Building Conservation comments

File Ref: 24/02355/FP

Address: The Studio, Manor Farm, Church Lane, Graveley, Herts SG4 7BN

Subject: Replacement of box dormer with two dormer windows on north roofslope and continued use of first floor as one 1-bed studio accommodation.

REAR ELEVATION

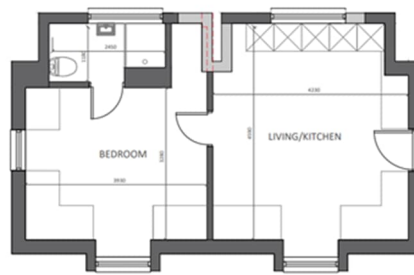
- 1.1 These comments follow on from my comments on 24 January 2025.
- 1.2 The two rear dormers as amended by drawing no.1397_YPUK_P006 P5 - Proposed Elevations received on 3 April 2025 (bottom image below) is, on balance, considered acceptable.

FIRST FLOOR PLAN

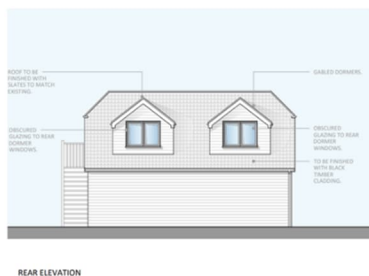
- 1.3 However, I still question the detail of drawing no. 1397_YPUK_P005 P5 - Proposed Plans. The front dormers are shown as projecting from the roof slope with available floor space set back either side of these dormers as I would expect to be the case. One would expect a similar approach to the rear with slightly wider dormers projecting from the roof slope. What is shown is a confusing arrangement which seems to imply that the rear dormers are 'recessed'. With useable floorspace either side of the dormers. The area tinted pink is key here as only **37.14m²** of floorspace is shown which includes these areas either side of the rear dormers.
- 1.4 Under ref: 23/01101/FP, the case officer wrote the following at paragraph 4.3.11 of his delegated note:

FIRST FLOOR PLAN (AREA)

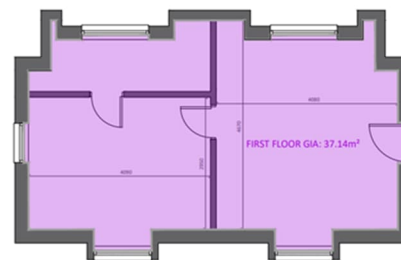
- 1.5 These standards state at page 5 that where a 1b1p has a shower room instead of a bathroom (which applies to this proposal), the floor area may be reduced from 39m² to **37m²**. Currently the proposal indicates a gross internal floor area that is only 0.14m² above the minimum standard. If, however, some of the tinted pink area is not considered to be useable floorspace then the unit is likely to fall short of the 'Technical housing standards – nationally described space standard'.
- 1.6 You may consider that I am labouring the point here, but this is not just about design, it is about ensuring the wellbeing of the occupant in what is a tight configuration. Once this is resolved I will advise on conditions.
- 1.7 My understanding is that the decision on the appeal against the refusal of appn ref: 23/01101/FP remains pending for the box dormer in the image below.
